PROPOSED REMODEL TO VALENITE BUILDING, GAINESVILLE	
SCALE: 1"=40'	APPROVED BY:
DATE: 8-28-05	REVIEWED:
BJ COMPANY CONTRACTORS, INC	
GAINESVILLE, TEXAS	
DRAWING NUMBER:

SITE PLAN 1"=40'-0"

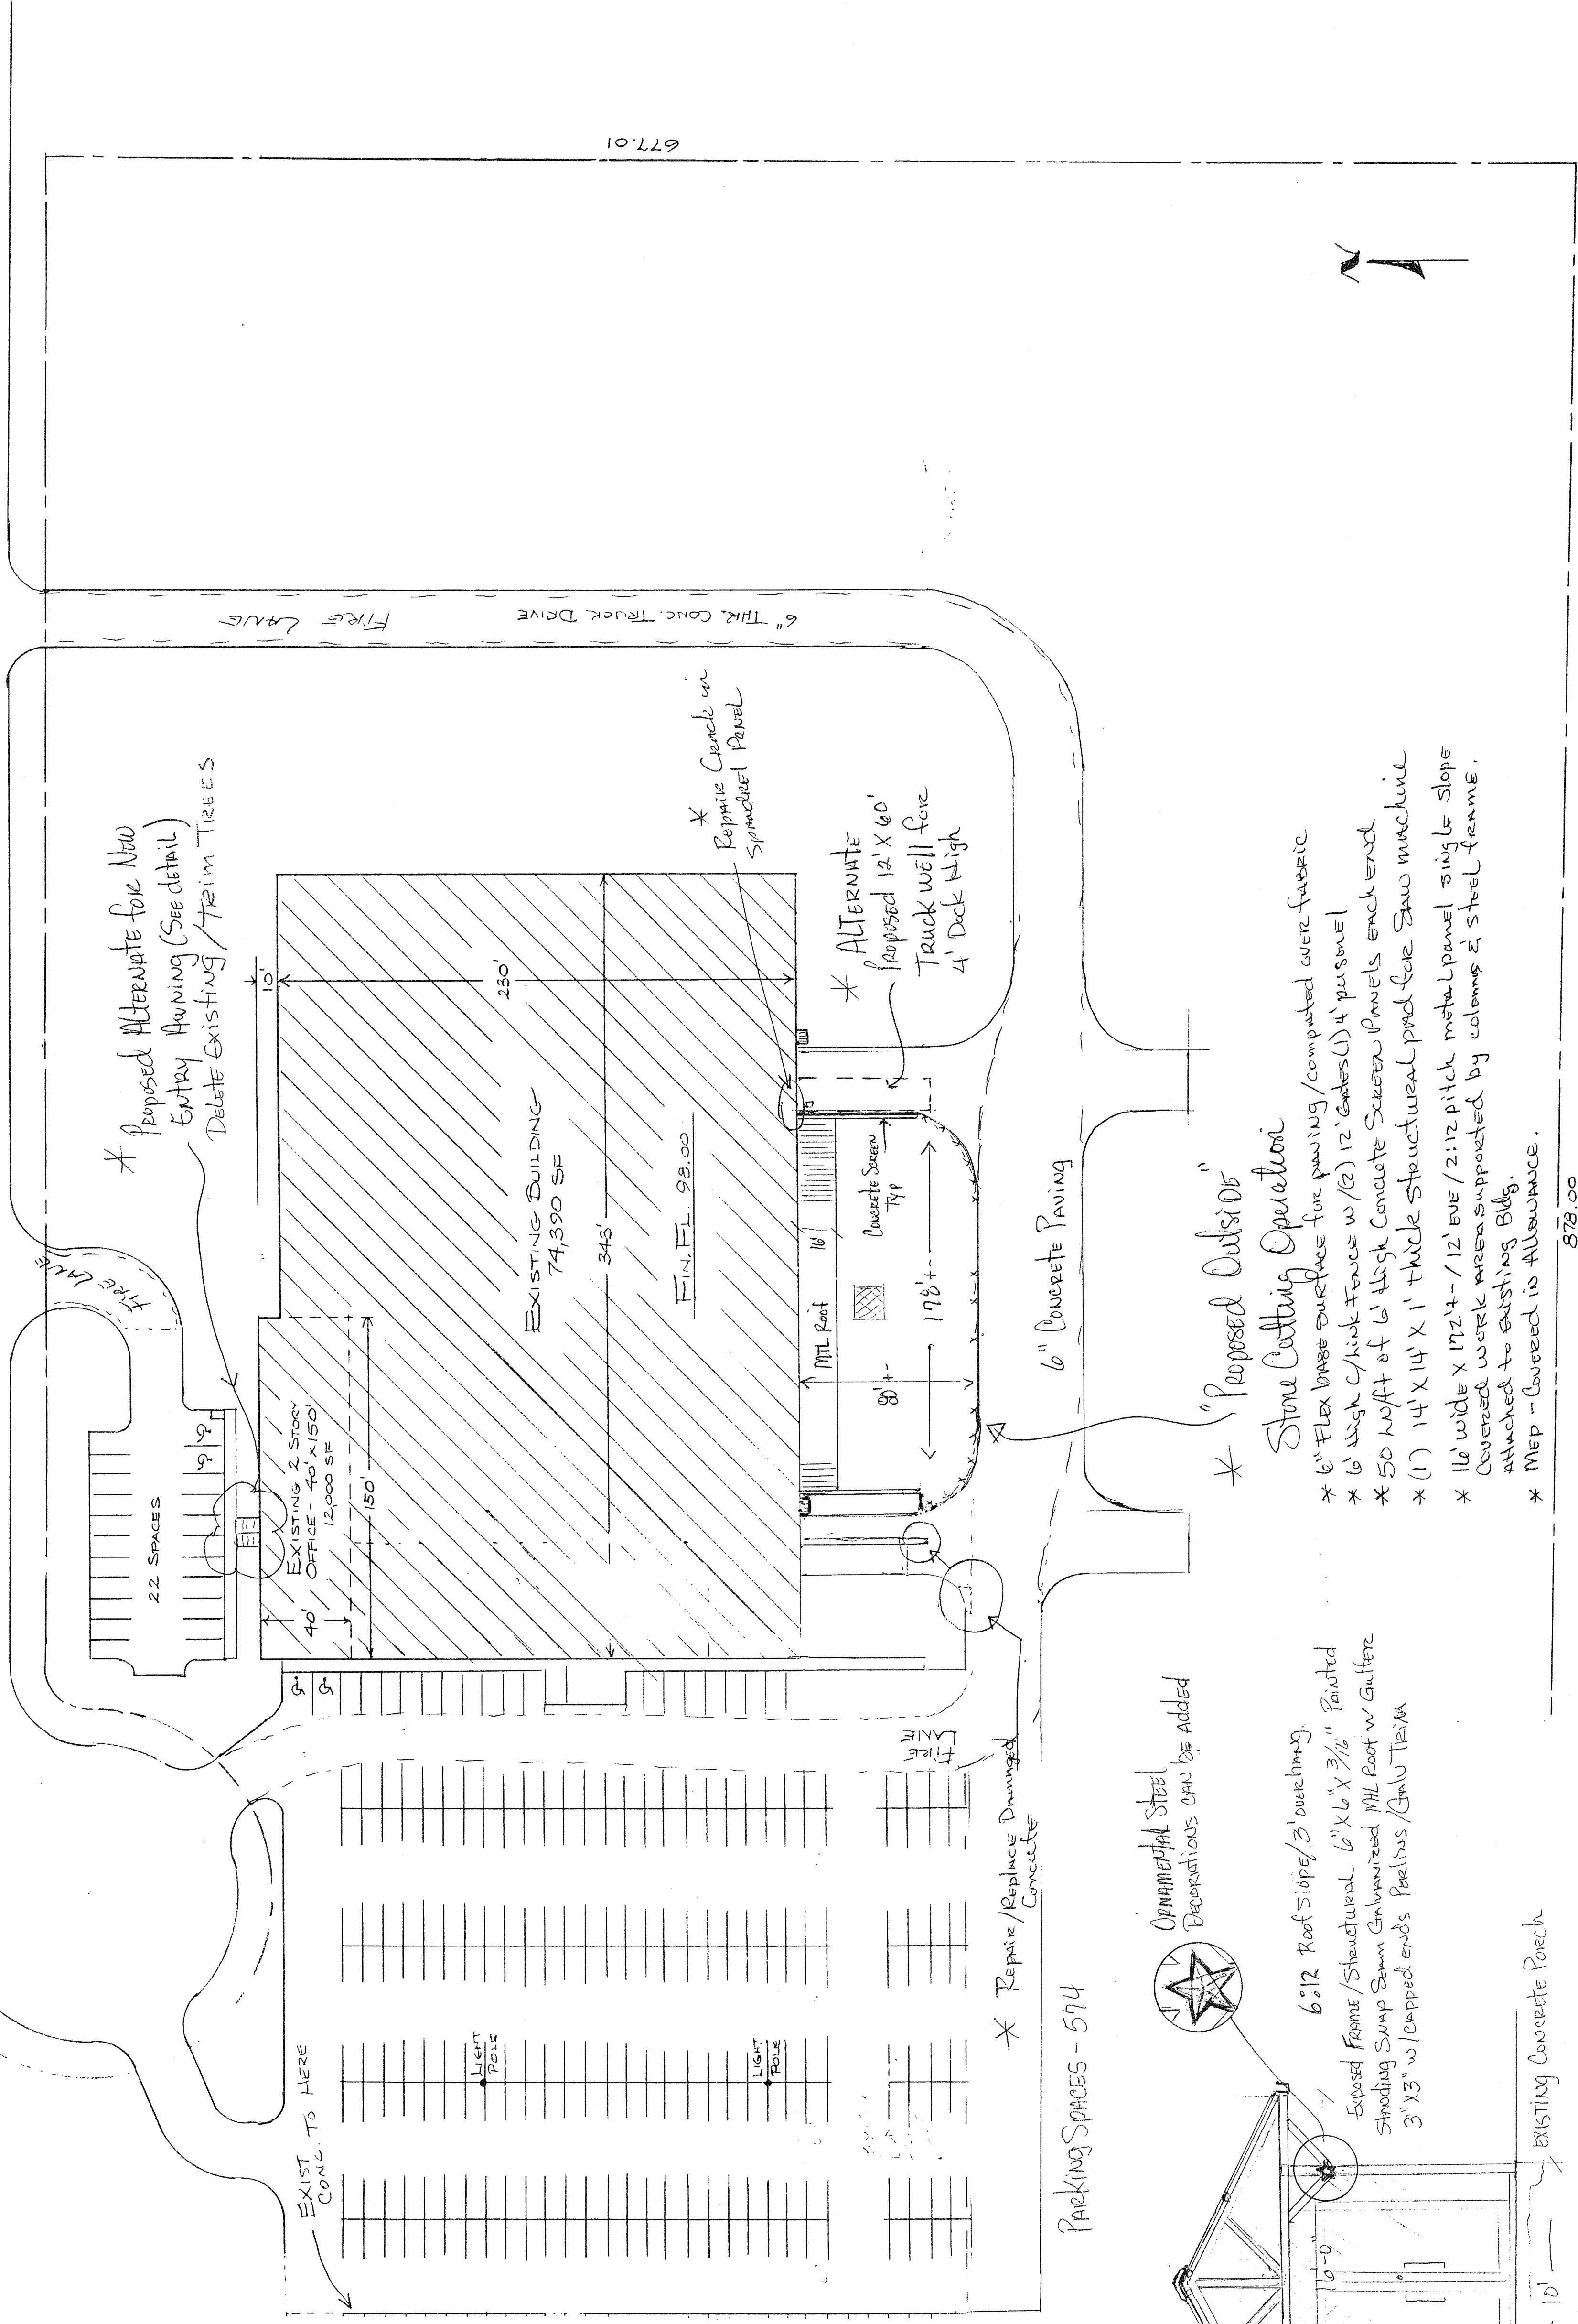
* Proposed Alternate for New Entry Awning (See Detail)
DELETE EXISTING TRIM TREES

* Repair Concrete in Symmetrical Panel

* ALTERNATE Proposed 12' X 60' Truck Well for 4' Deck High

* "Proposed Outside" Stone Cutting Operation

- * 6" Flex base surface for paving/computed over fabric
- * 6' High Chain Fence w/ (2) 12' Gates (1) 4' Personnel
- * 50' High of 6' High Concrete Screen Panels each end
- * (1) 14' X 14' X 1' thick structural prod for Saw machine
- * 16' wide X 12:12 - 12' BVE / 2:12 pitch metal panel single slope covered work area supported by columns & steel frame.
- * Attached to existing Bldg.
- * MEP - Covered is Allowance.

Flash to Bldg Saw-cut Right. EXISTING WALL IS CONCRETE

6:12 Roof Slope / 3' overhang. Exposed Frame / Structural 6" X 6" X 3/8" Painted Standing Sump Sump Galvanized Mill Roof w/ Gutter 3" X 3" w/ capped ends Purlins / Galv Tie/BA
